Department of Energy

As discussed during our September 15th public meeting, enclosed please find the Environmental Management Advisory Board EM Tank Waste Subcommittee Report for Waste Treatment Plant; Report Number EMAB EM-TWS WTP-001, September 30, 2010, in accordance with the Work Plan directive dated May 10, 2010. This report covers the work plan observations and recommendations concerning the Waste Treatment and Immobilization Plant at Hanford (WTP). The charge is summarized below.

Environmental Management Advisory Board
EM Tank Waste Subcommittee Report for Waste Treatment Plant
Report Number EMAB EM-TWS WTP-001

Figure C-2. Comparisons of design wear allowances to the predicted 40-year wear (24590-WPT-RPT-PET-08-008, Rev. 0)

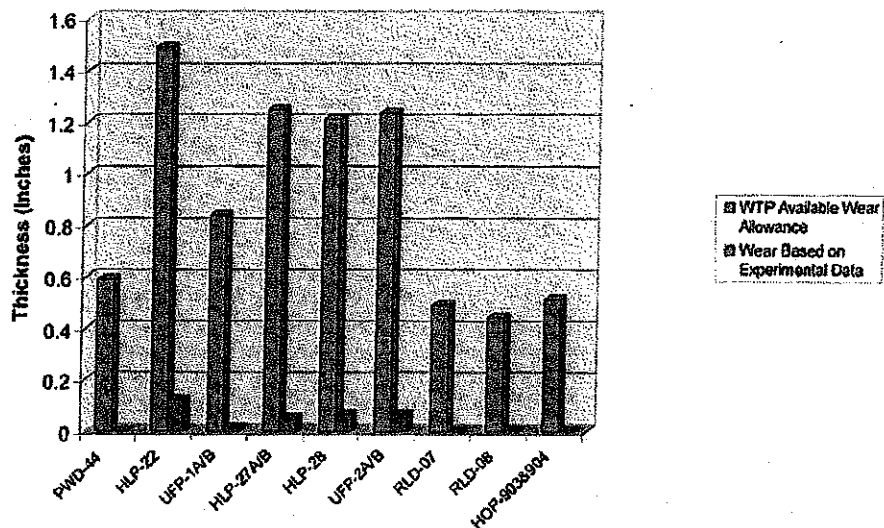
This issue was resolved by performing tests that verified that the curve used (Figure C-2) was a conservative estimate of erosion. Although run with simulants, these tests should provide a reasonable basis for closure of this issue. However, it was acknowledged that the largest particles cause the wear and the effect is highly non-linear (Page 6 of 24590-WPT-RPT-PET-08-008, Rev. 0), but only the weighted average particle size was used as the parameter to validate the test slurry. It appears that this had no significant effect since the wear curve used for design was still more conservative than that representing the largest particles used in these tests (54 microns).
